Sumter City-County Planning Commission

MSP-26-42/HCPD-26-20: 440 Theatre Dr. (City)

**MSP-26-42/HCPD-26-20: 440 Theatre Dr.
Bobby Richardson Sports Complex
Renovation Proposed Conditions of Approval**

Figure 6 - Proposed Storm Drainage Plan (Sheet C300)

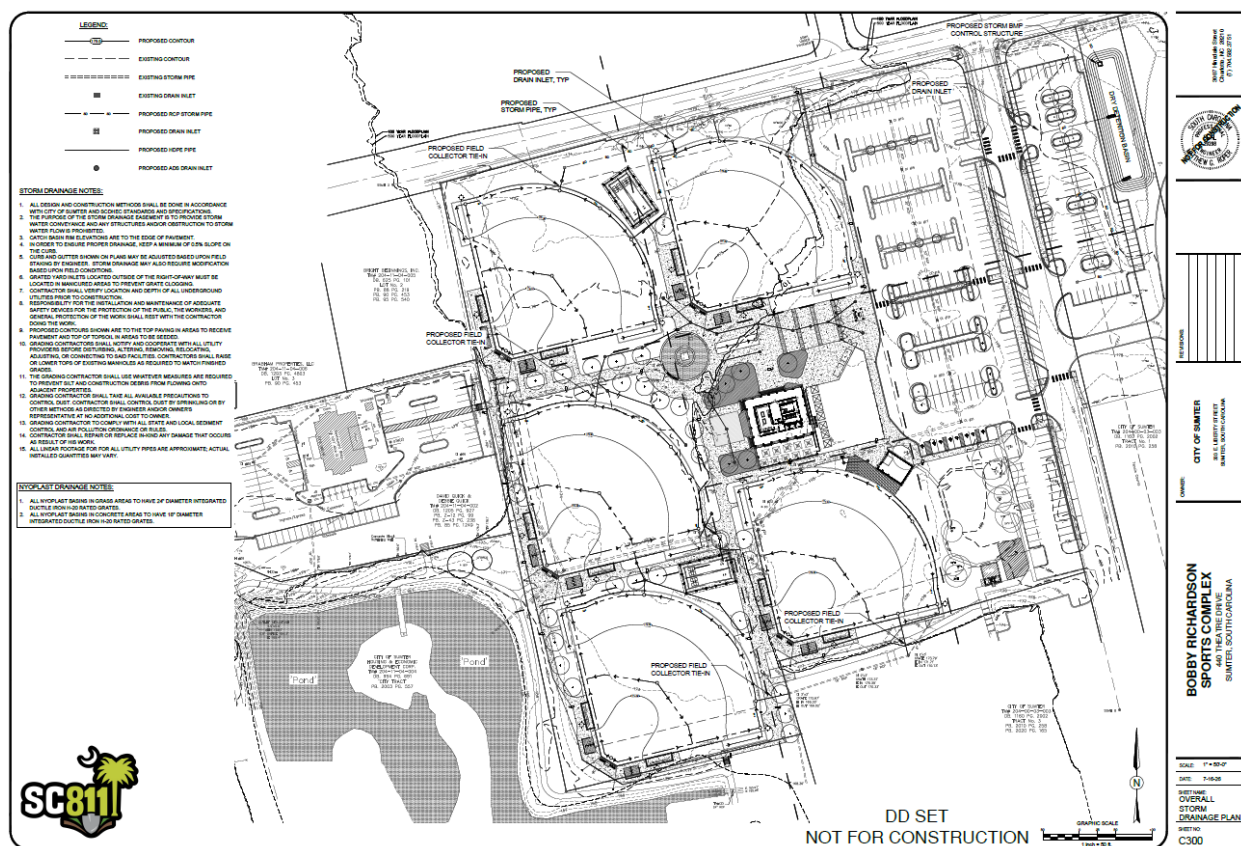
Stormwater run-off from the site will be collected and piped to a detention/infiltration pond to be located to the northeast of the developed area, between Theatre Dr. and Palmetto Parkway.

The proposed project requires a City of Sumter stormwater permit. Coverage under the NPDES General Permit for Stormwater Discharges from Large and Small Construction Activities is pending with the S.C. Department of Environmental Services.

- b. Stormwater permit approval and NPDES concurrence letter from the City Stormwater Utility must be submitted to the Sumter City-County Planning Department.

OVERALL
LAYOUT PLAN

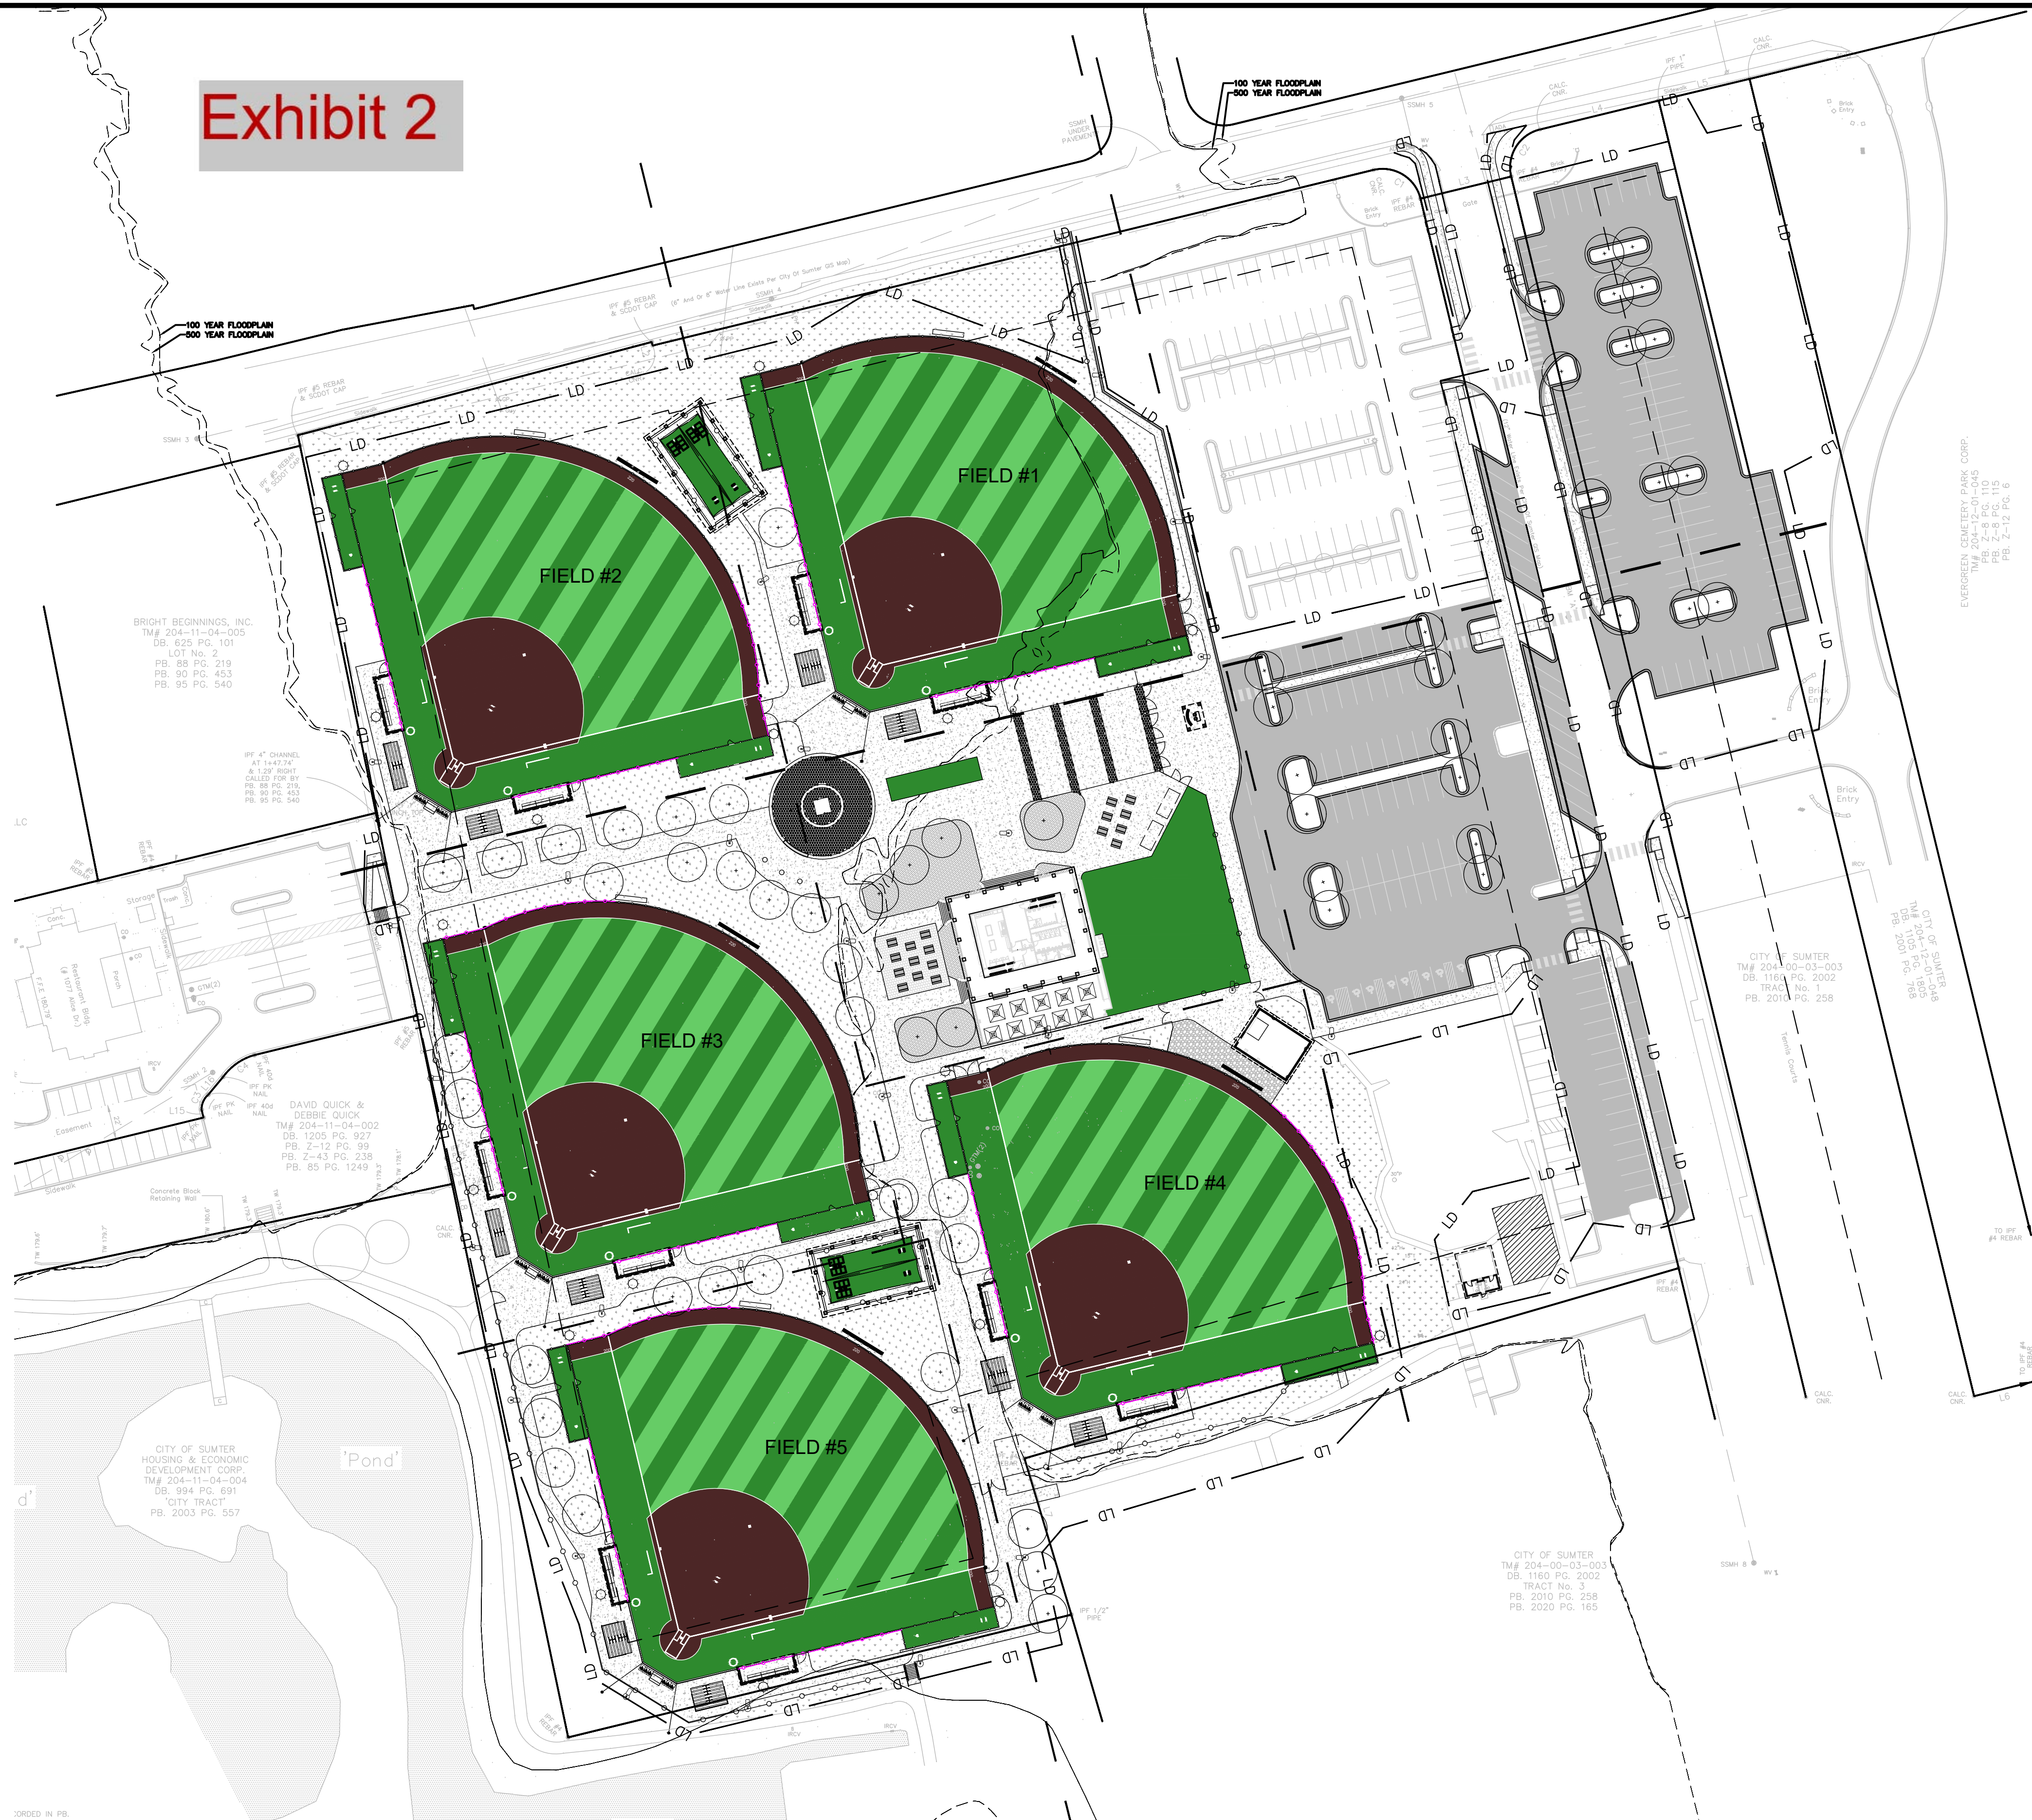
Site development must adhere to the Institutional General (IG) zoning district standards of the proposed *City of Sumter Unified Development Ordinance*. The proposed development meets the minimum standards and development criteria as outlined in the following table:

Development Standard	Minimum Ordinance Requirement	Proposed
Front Setback	15 ft	42 ft
Exterior Side Setback	10 ft	253.8 ft
Interior Side Setback	15 ft	4.8 ft*
Rear Setback	10 ft	21 ft
Maximum Impervious Surface	50%	<40%
Maximum Building Height	55 ft	20 ft

*Variances to building setback requirements granted by the Sumter City-County Board of Zoning Appeals via BOA-26-04.
